工程指示 / 要求簡箋 ENGINEER INSTRUCTIONS (E.I.)

| 工程指示編號: | EI- 4790D | 修改版本: | D |
| 工程編號: | J 853 | 工程名稱: | 大窩坪 (延坪道) |
| 工程項目: | T3 幕牆單元件生產 (大貨) (修訂D:修改Z字碼設計及修改分格呎吋) | 日期: | 29/07/2022 |

| 名稱 | 生窗玉組裝圖 | 制圖 | 付吉寧 | 2022.05.20 | 修改 | A | |

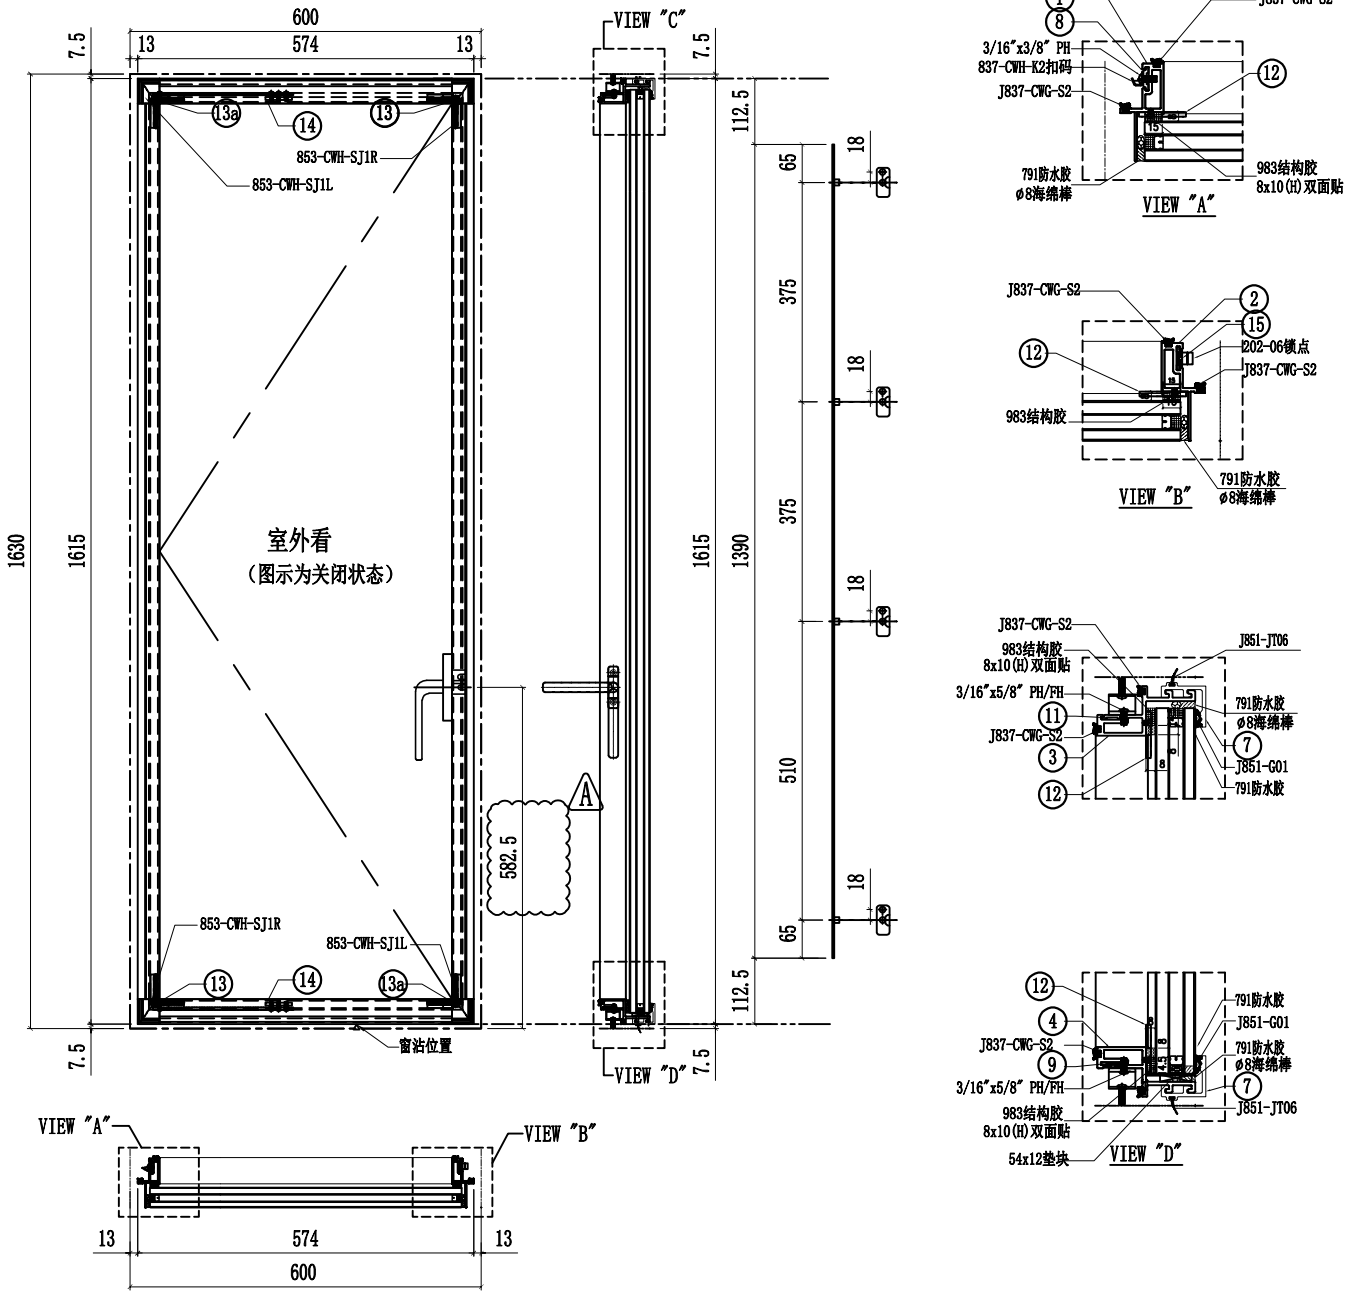
雲線處依據EI-4891 修改手柄高度

| 名稱 | 生窗玉組裝圖 | 制圖 | 付吉寧 | 2022.05.20 | 修改 | A |

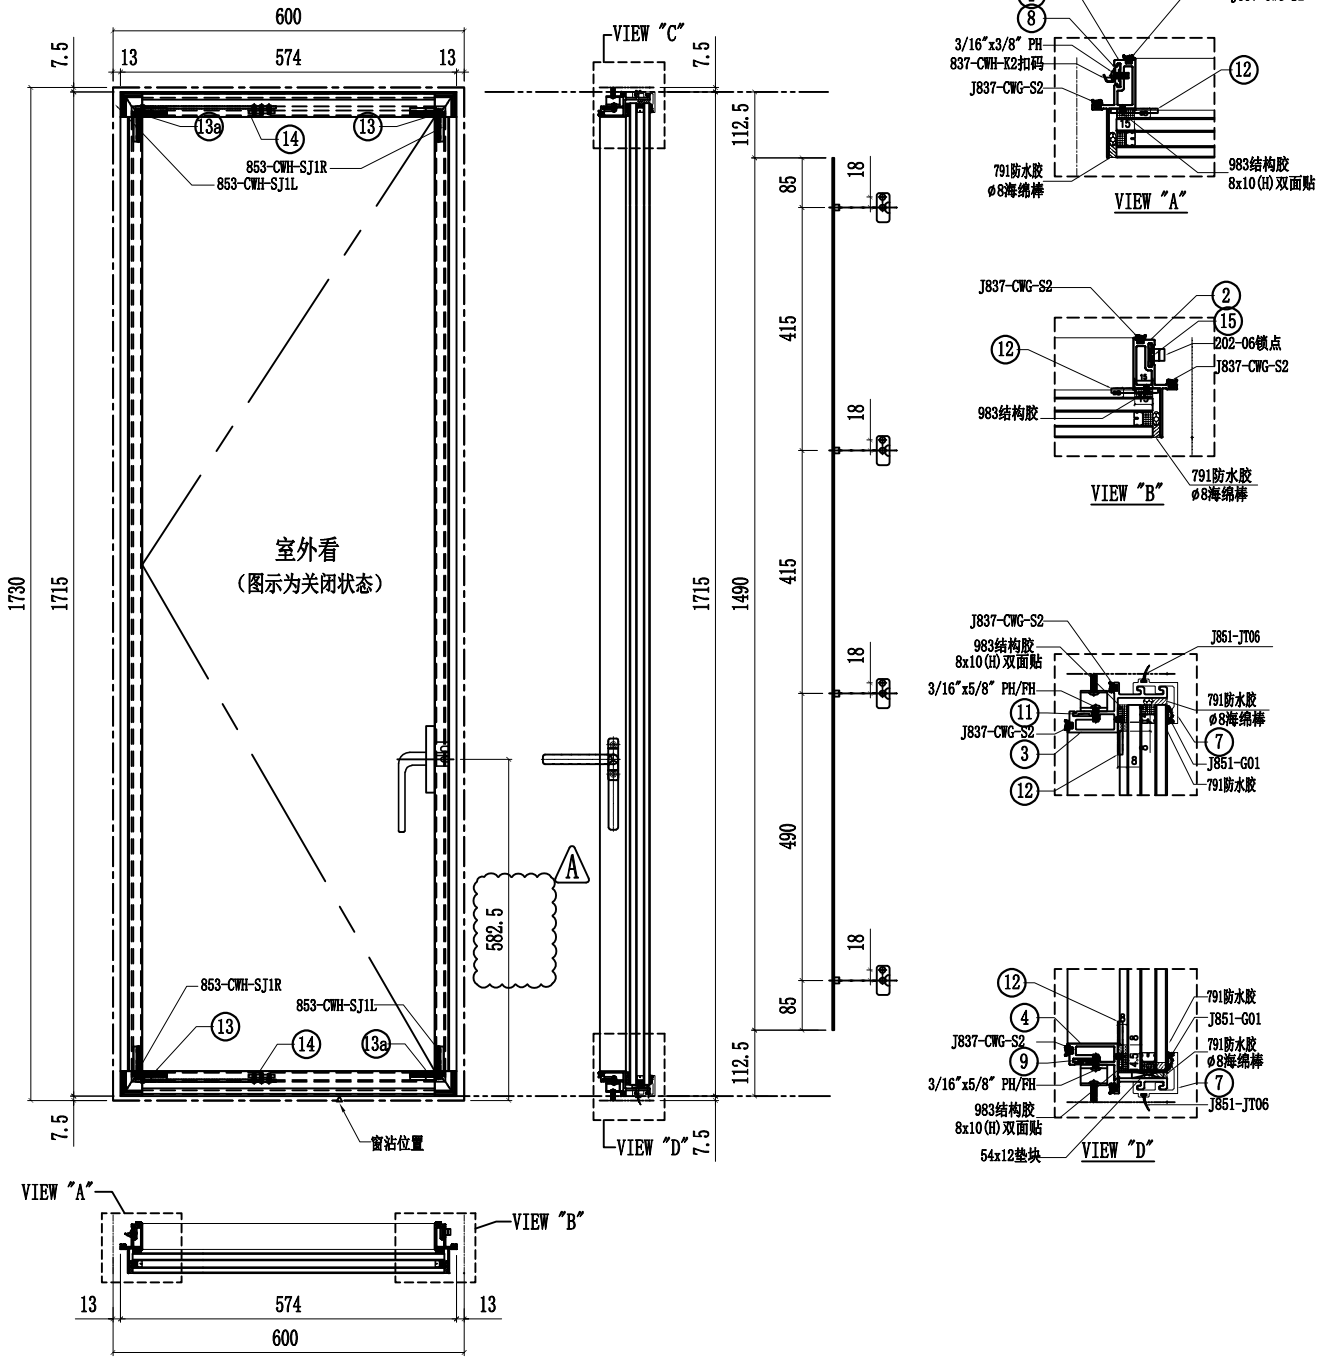
雲線處依據EI-4891 修改手柄高度

| 名稱 | 生窗玉組裝圖 | 制圖 | 付吉寧 | 2022.05.20 | 修改 | A | |

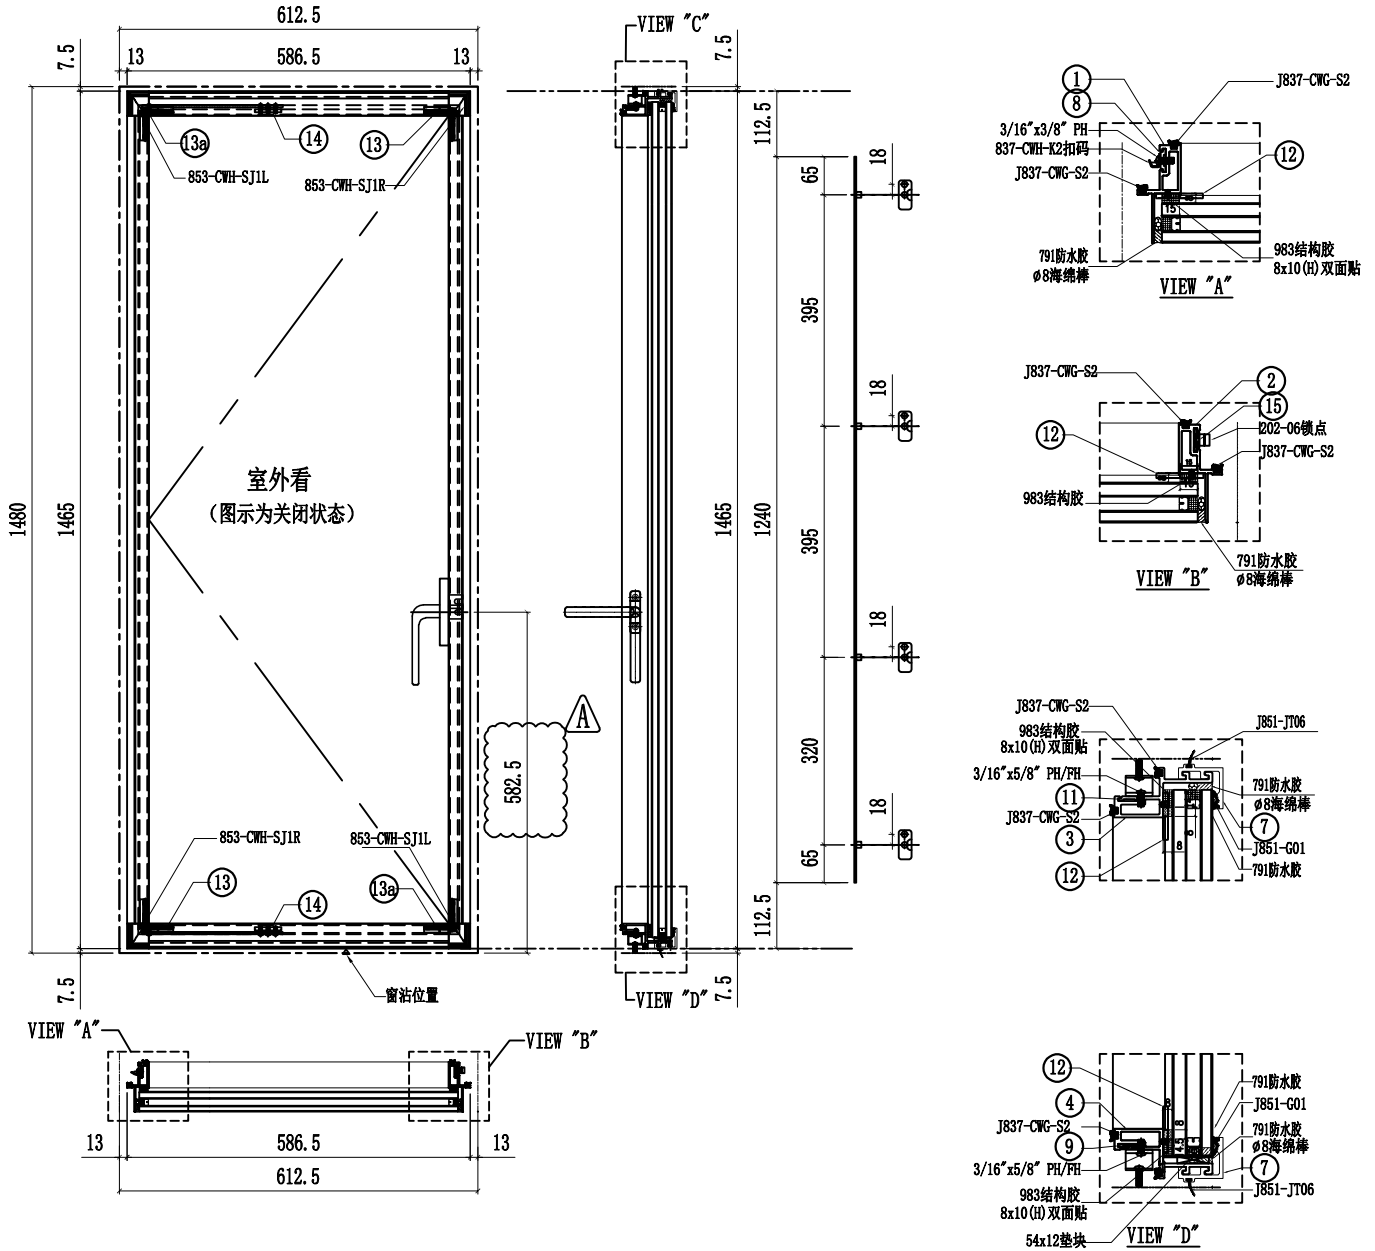
雲線處依據EI-4891 修改手柄高度

| 名稱 | 生窗玉組裝圖 | 制圖 | 付吉寧 | 2022.05.20 | 修改 | A |

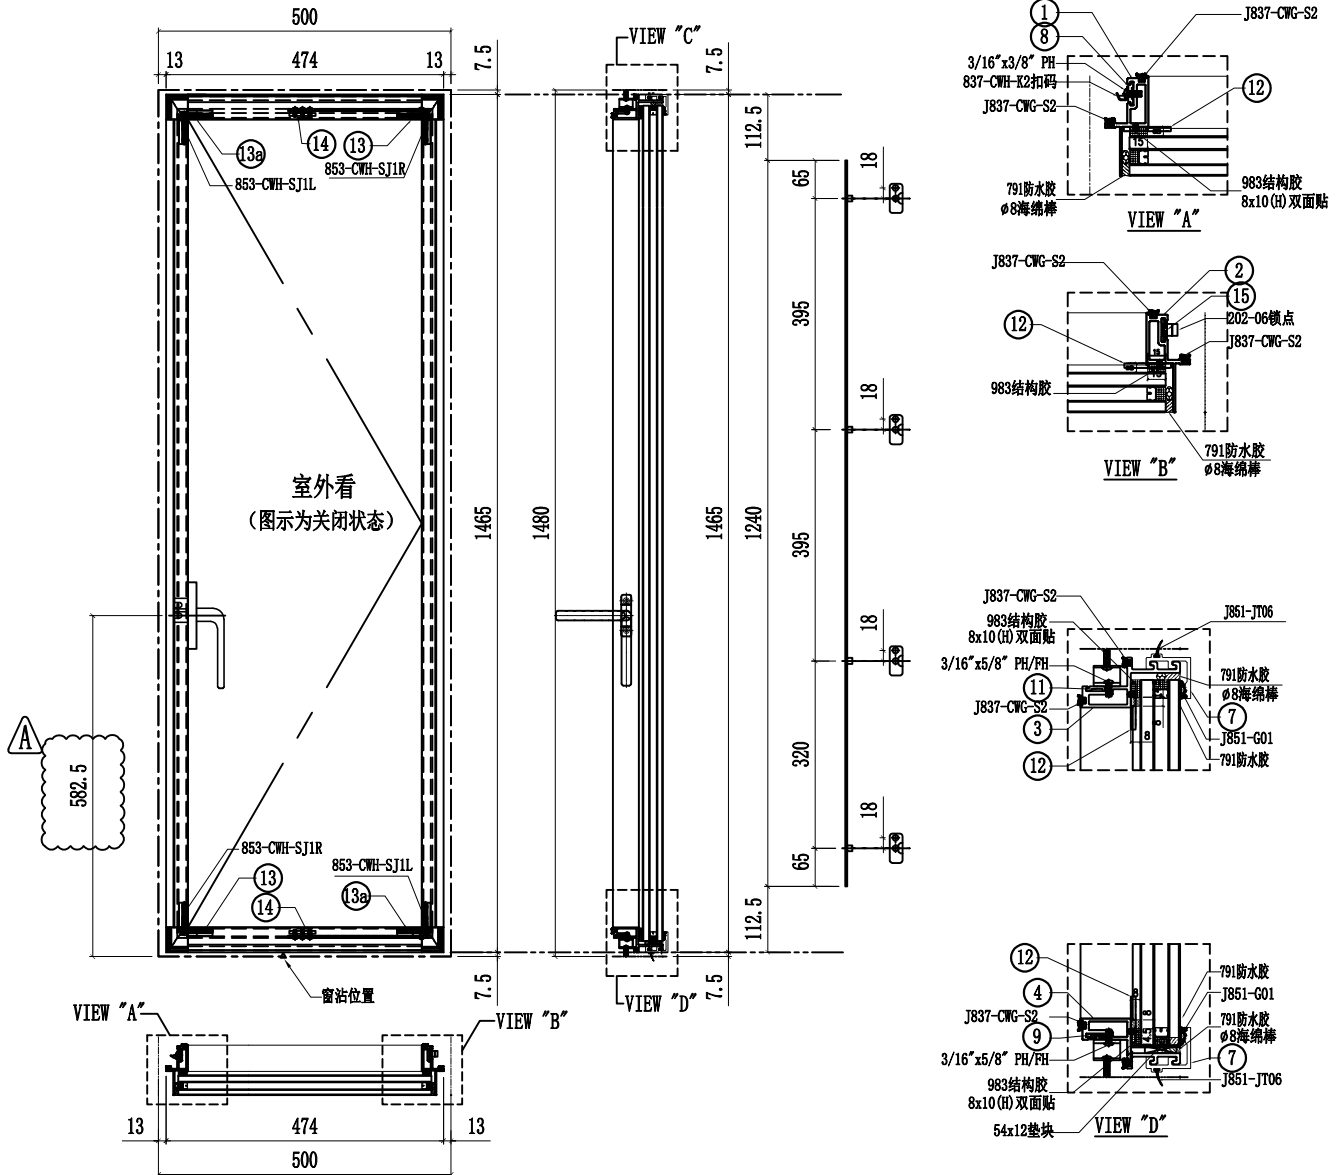
雲線處依據EI-4891 修改手柄高度

| 名稱 | 生窗玉組裝圖 | 制圖 | 付吉寧 | 2022.05.20 | 修改 | A |

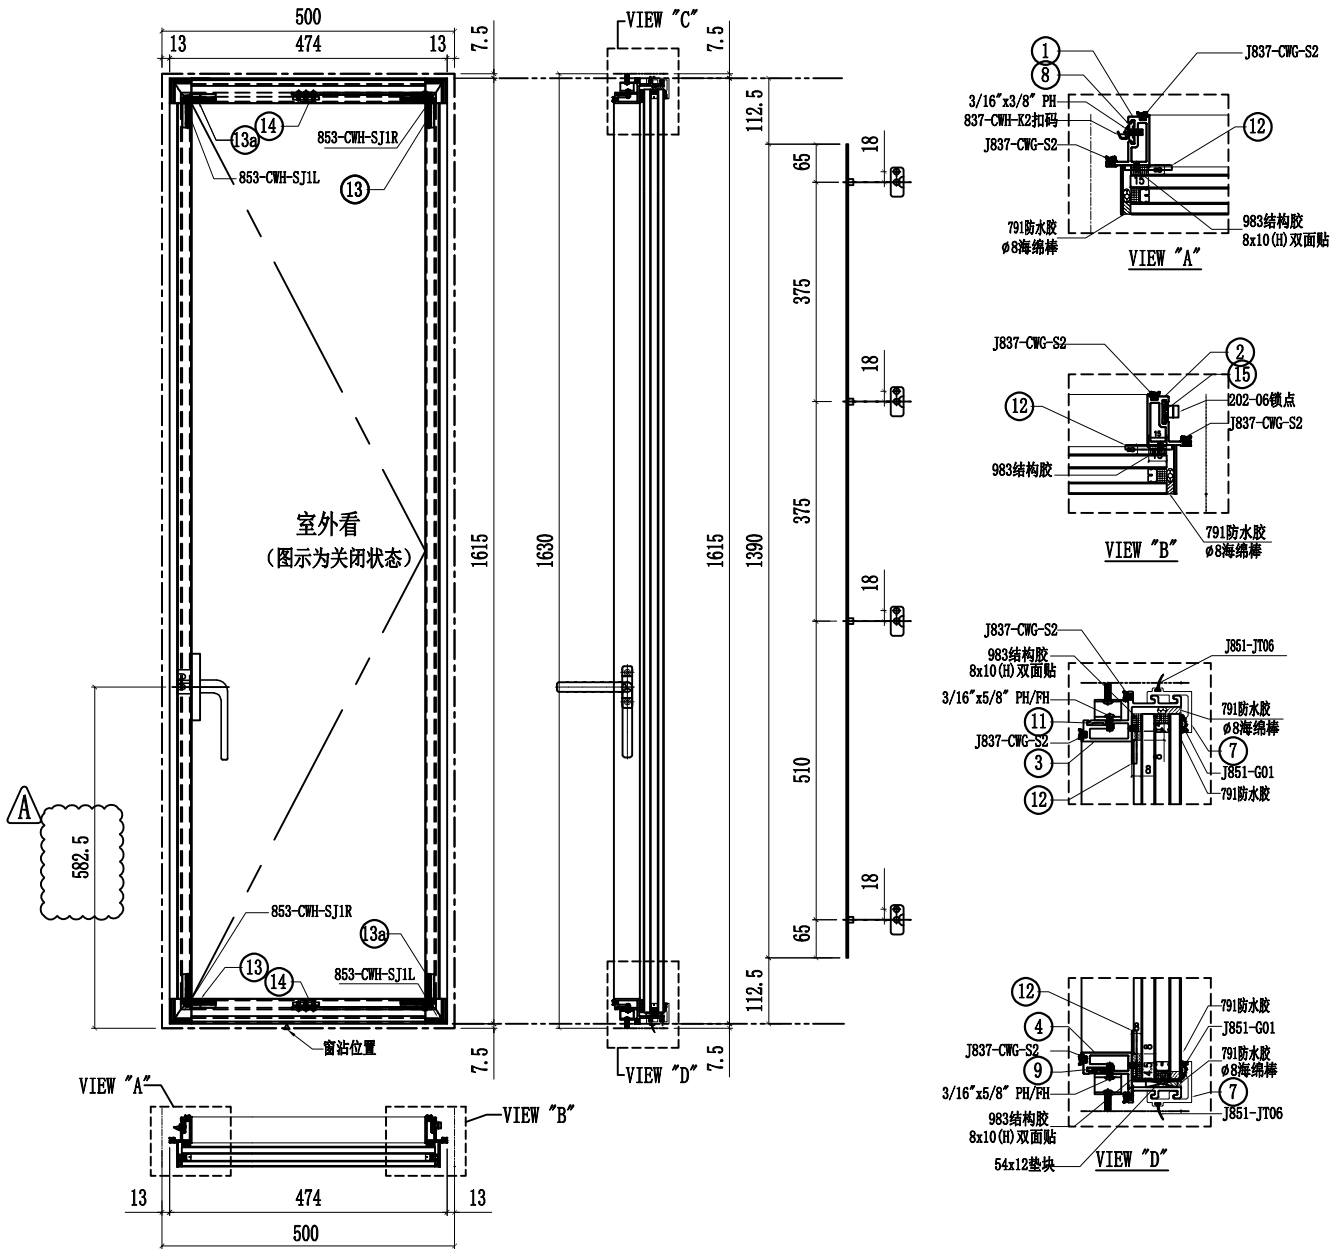
雲線處依據EI-4891 修改手柄高度

| 名稱 | 生窗玉組裝圖 | 制圖 | 付吉寧 | 2022.05.20 | 修改 | A |

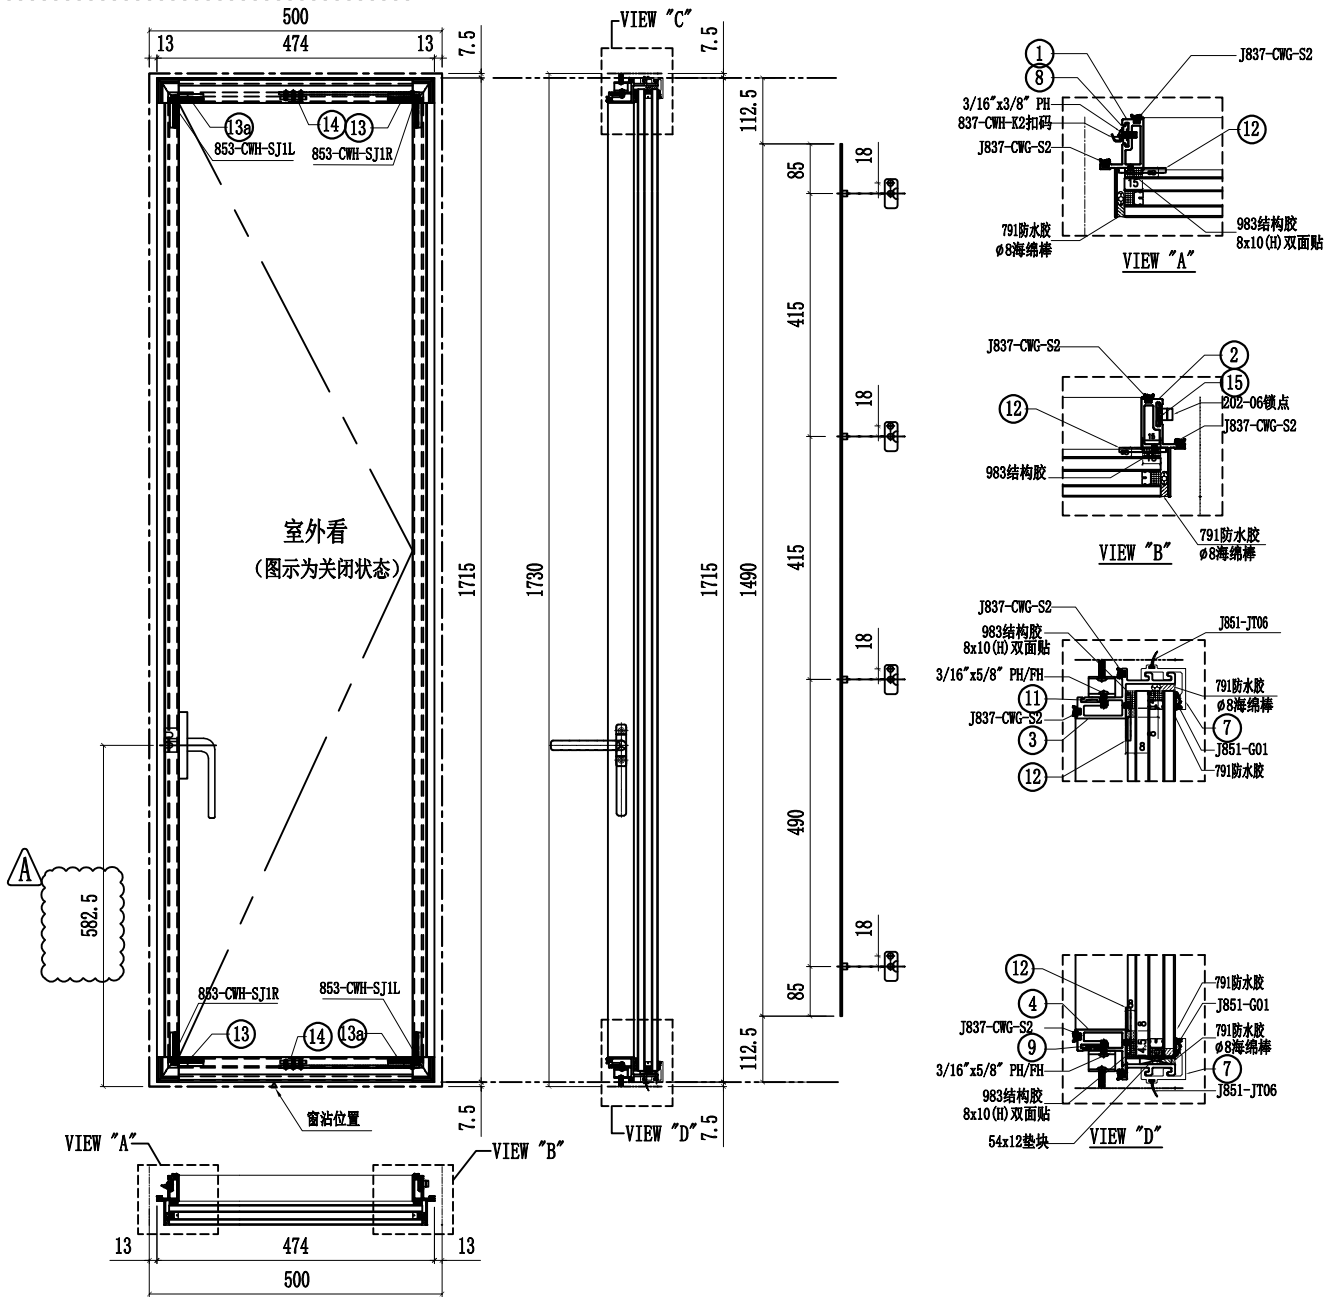
雲線處依據EI-4891 修改手柄高度
